ETOD Detailed Site Plan Departure from Design Standards (Two Town Center)

DSP-20036
DDS-673

SUBJECT: Detailed Site Plan DSP-20036
Type 2 Tree Conservation Plan TCP2-038-2020
Alternative Compliance AC-20012
Departure from Design Standards DDS-673
Two Town Center
Expedited Transit-Oriented Development Project

SITE PLAN
SCALE: 1" = 50'

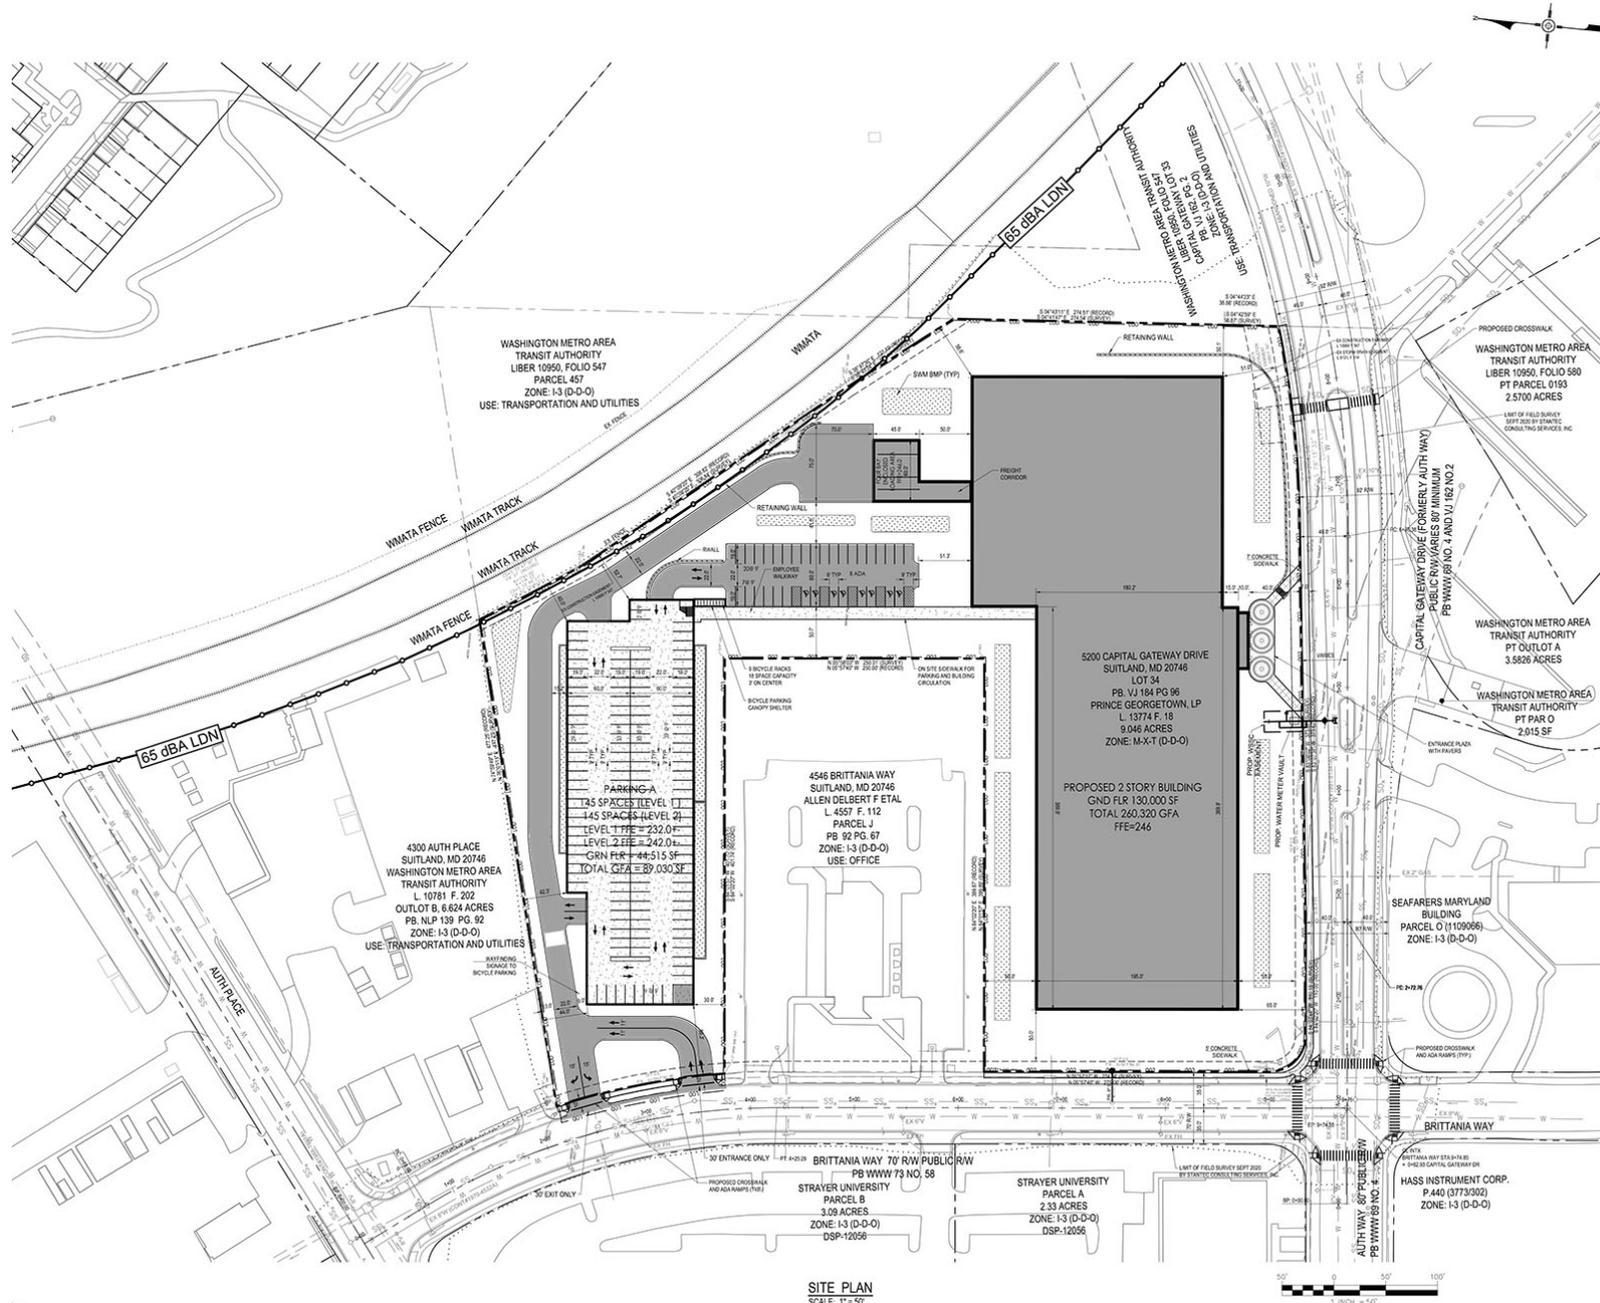
The submitted plans propose a 7-foot-wide sidewalk along the frontage of Capital Gateway Drive and a 5-foot-wide sidewalk along the frontage of Britannia Way. Staff recommends that 8-foot-wide sidewalks along both roadway frontages be provided, consistent with this condition, unless modified by the Prince George's County Department of Permitting, Inspections and Enforcement (DPIE), with written correspondence.

In addition to complying with the prior condition of approval, 8-foot-wide sidewalks are consistent with the 2017 *DPW&T Urban Street Design Standards*, which include 8-foot-wide sidewalks in all but the "industrial" and "neighborhood residential" cross sections. Neither Capital Gateway Drive nor Britannia Way are master plan roadways, and no additional right-of-way dedication is required with this development application. Capital Gateway Drive has an approximate 80-foot-wide right-of-way and Britannia Way has an approximate 60-foot-wide right-of-way. Both streets could be built with 8-foot-wide sidewalks and meet the Urban Design
